Our ref: DOC20/236184

Senders ref: SSD 8445

Subject: Tahmoor South Project – Response To Submissions (SSD 8445)

Attachment B – Suggested amendment to longwalls in vicinity of Dog Trap Creek

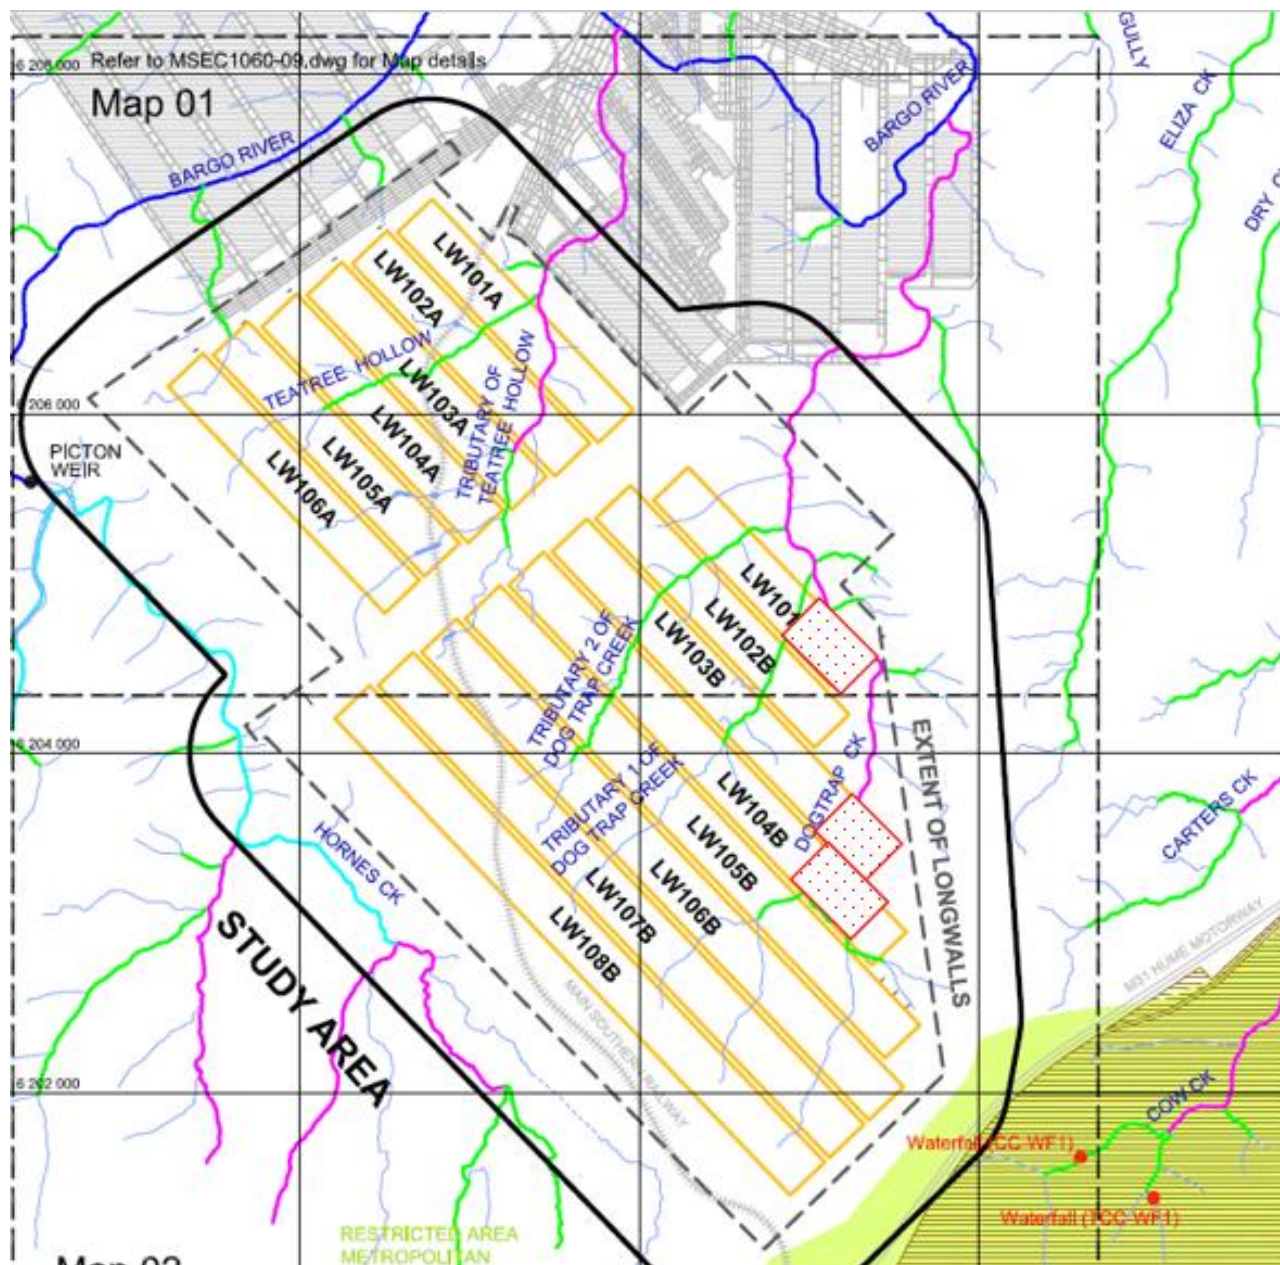
- However, we note there remains some outstanding issues around avoidance of significant features, notably streams and threatened native vegetation for some surface disturbance areas, as detailed at Attachment A (Key Issues 1, 2 & 7). Further amendments to the longwall layout to reduce impacts upon 3rd order streams and sites of Aboriginal cultural heritage at Dog Trap Creek are suggested at Attachment B.

- We maintain our recommendation that reductions to the southern extents of Longwalls 101B and 103B would help further protect the Dog Trap Creek site complex from the impacts of subsidence. This would remove longwall mining under an additional three Aboriginal heritage sites comprising rock shelters with art.

Reduction of longwalls
to avoid 3rd order Dogtrap Ck
